# West Burton Solar Project

## Environmental Statement Addendum: Chapter 10: Hydrology, Flood Risk and Drainage

PINS reference: EN010132  
Document reference: EX1/WB8.4.10.1  
APFP Regulation 5(2)(a)

| Document Title:      | Figure 4.1 Illustrative Site Layout Plan (WB1) Revision A<br>Document Ref: EX1\WB5-4.4.1_A<br>AFFP Regulation: 5(2)(a) |               |

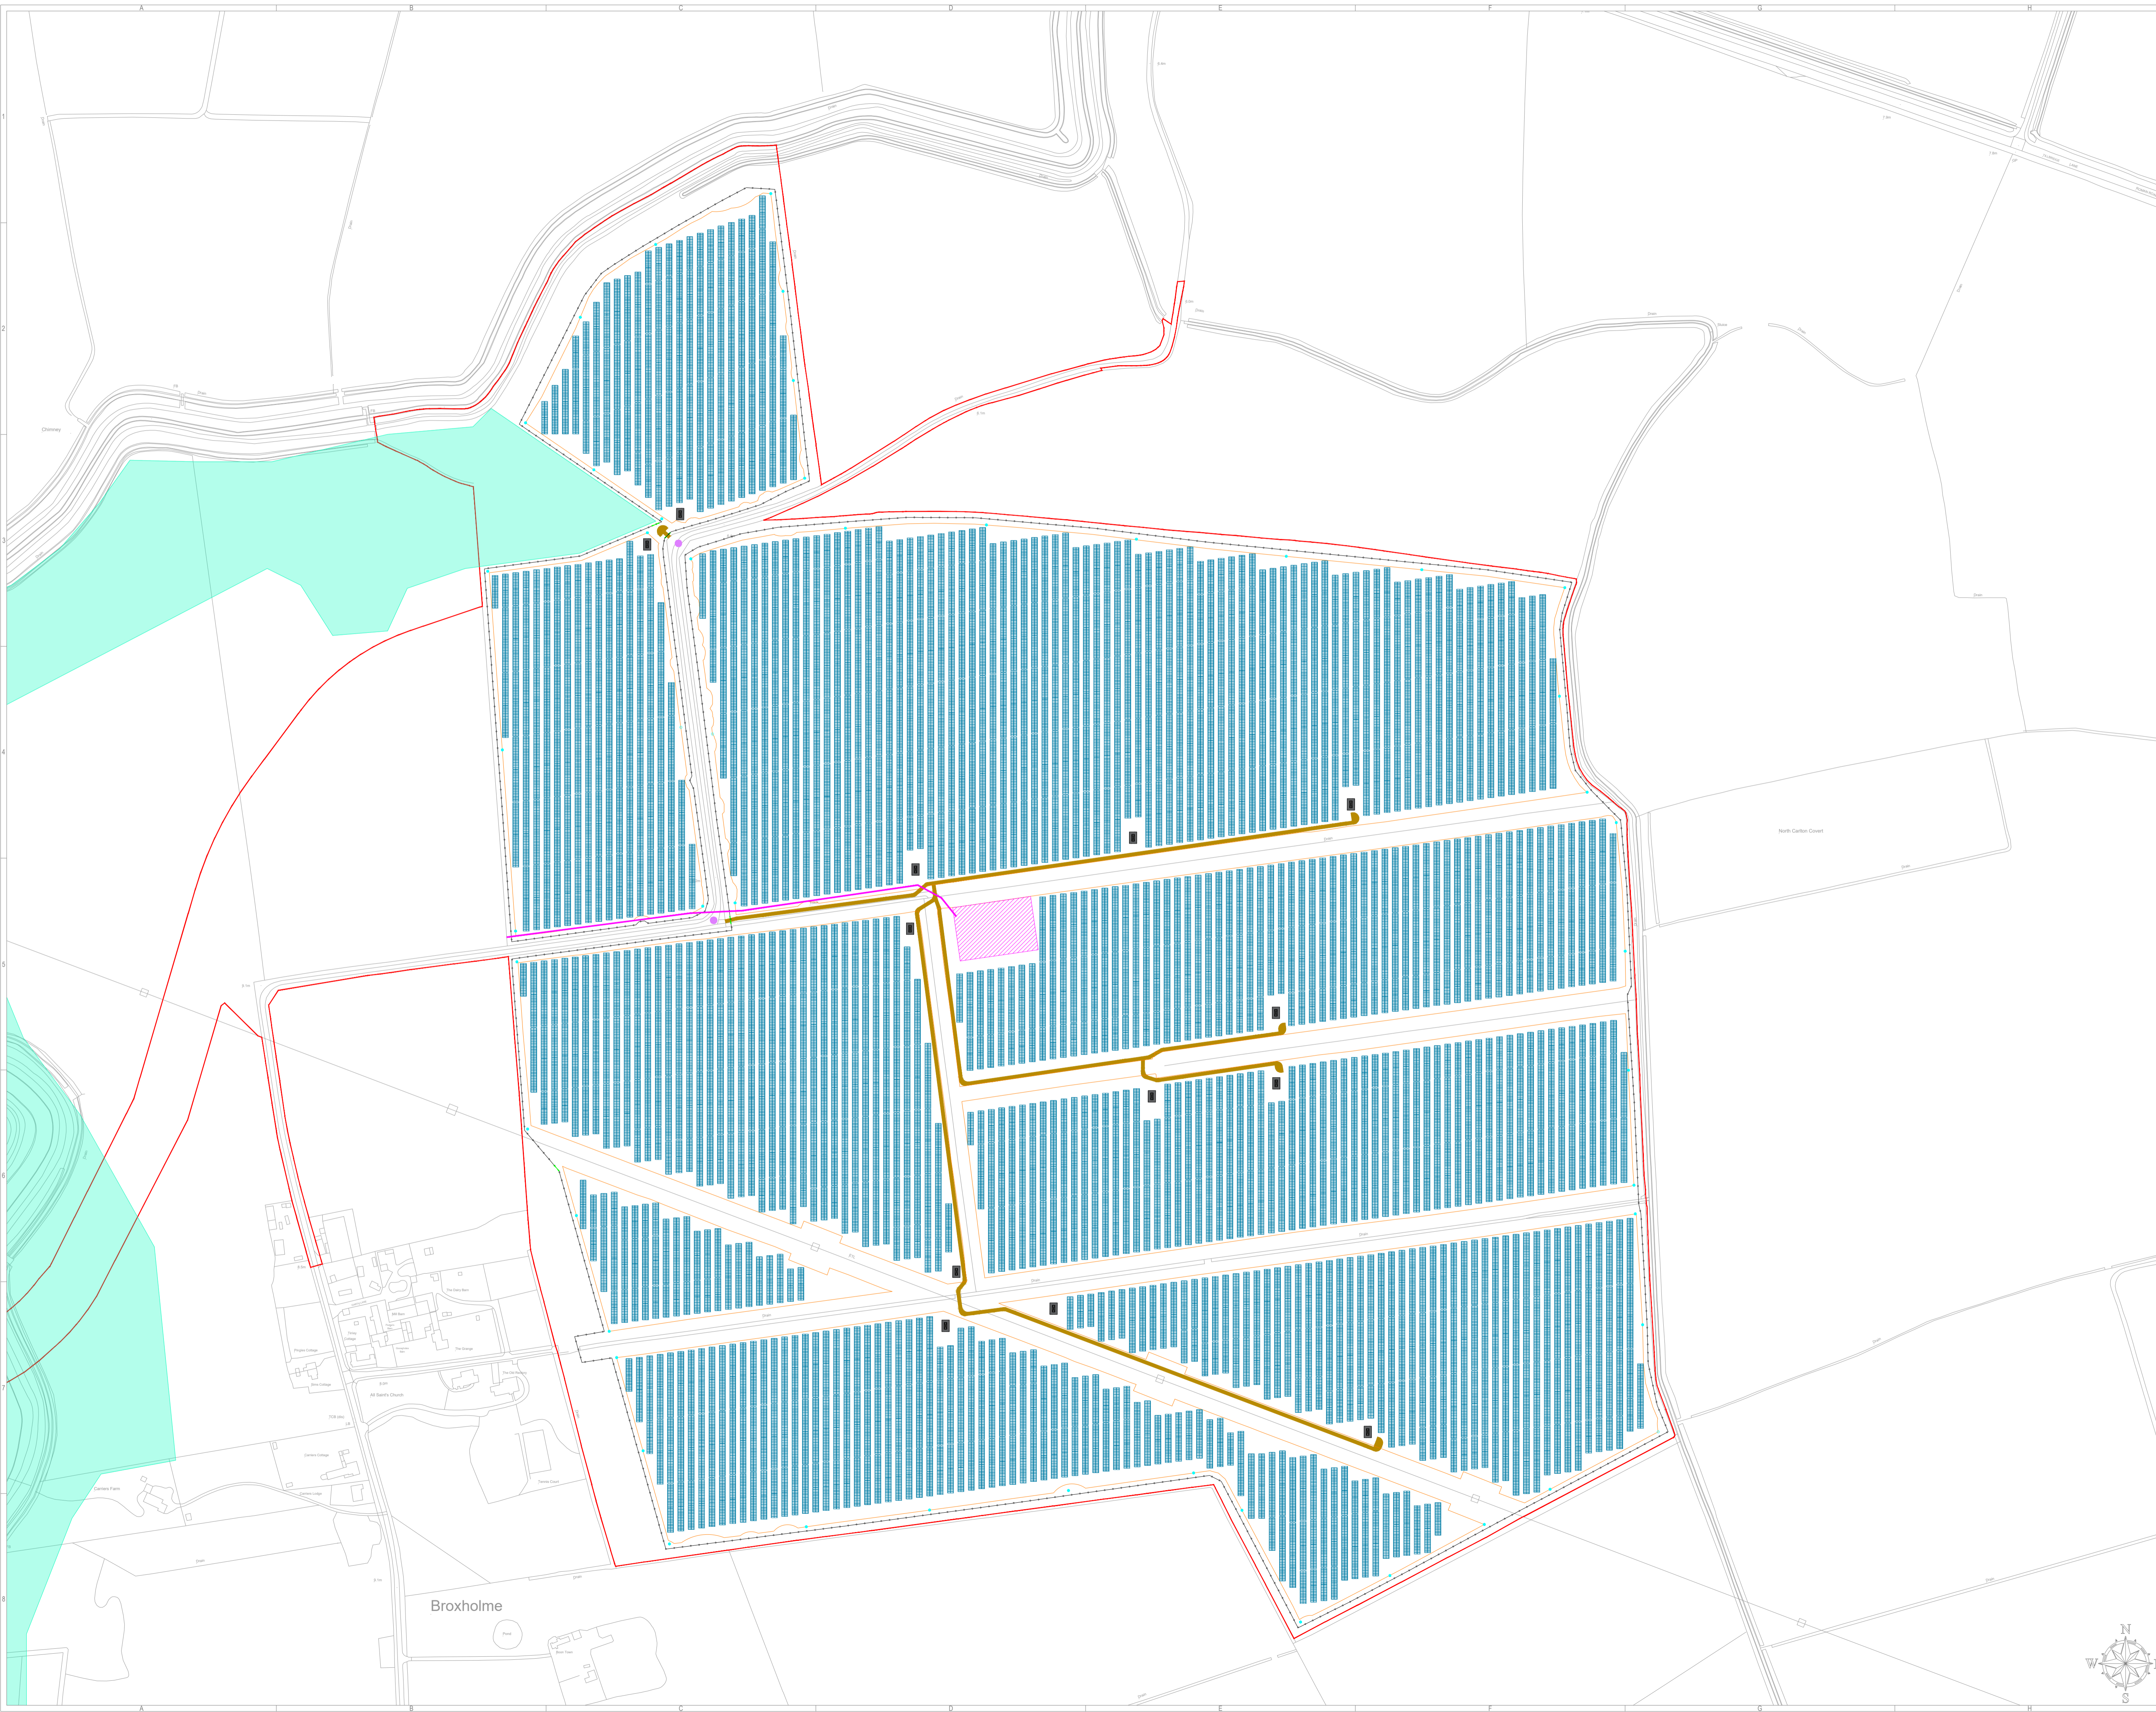
3.2.1 Annex D - Illustrative Layout Plan at page 24 of **6.3.10.3 Environmental Statement - Appendix 10.3 Flood Risk Assessment and Drainage Strategy for West Burton 1 [APP-091]** is to be updated to show the extent of the River Till Flood Storage Area and the area of the Order Limits that falls within the area. The updated plan is shown at Appendix A below. This is the same as the revised plan **WB6.4.4.1\_A ES Figure 4.1 - Illustrative Site Layout Plan West Burton 1 Revision A [EN010132/EX1/WB6.4.4.1\_A]** as submitted at Deadline 1.

| <b>Document Title:</b>   | Figure 4.2 Illustrative Site Layout Plan (WB2) Revision A<br>Document Ref: EX11WBS.4.4.2_A<br>AFFF Regulation: 5(2)(a) |

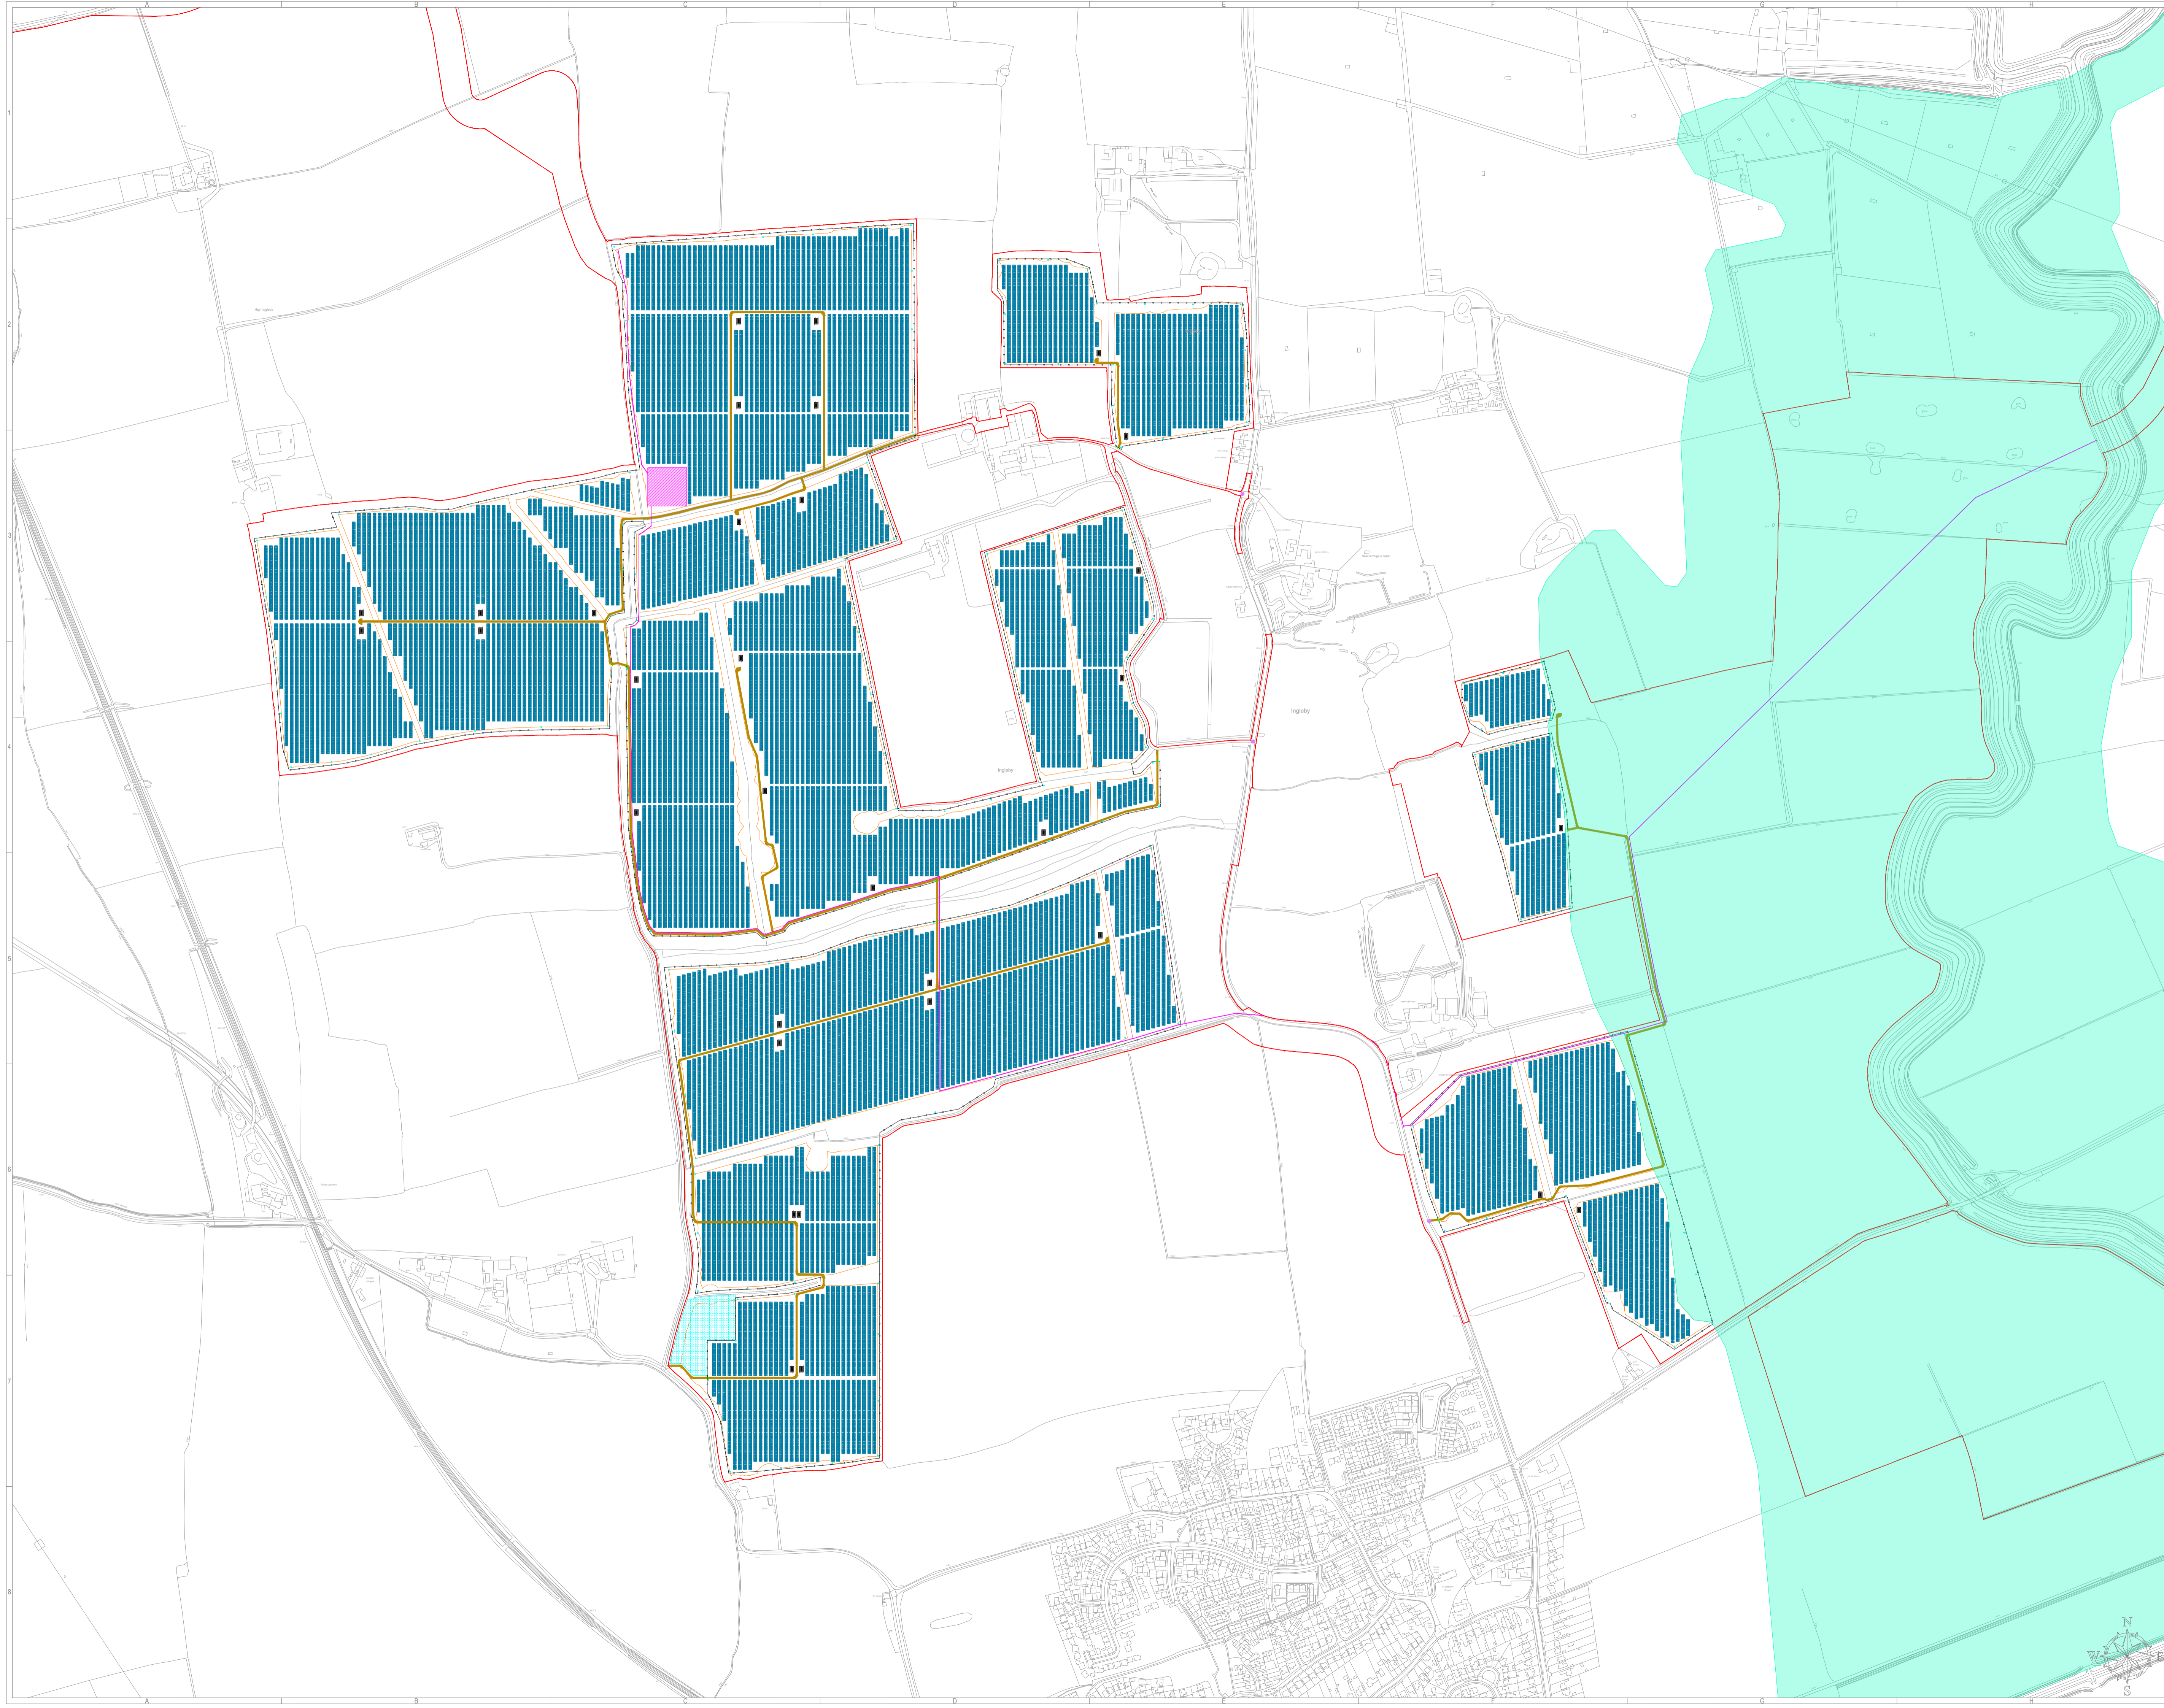
3.3.1 Annex D - Illustrative Layout Plan at page 24 of **6.3.10.4 Environmental Statement - Appendix 10.4 Flood Risk Assessment and Drainage Strategy for West Burton 2 [APP-092]** is to be updated to show the extent of the River Till Flood Storage Area and the area of the Order Limits that falls within the area. The updated plan is shown at Appendix B below. This is the same as the revised plan **WB6.4.4.2\_A ES Figure 4.2 - Illustrative Site Layout Plan West Burton 2 Revision A [EN010132/EX1/WB6.4.4.2\_A]** as submitted at Deadline 1.
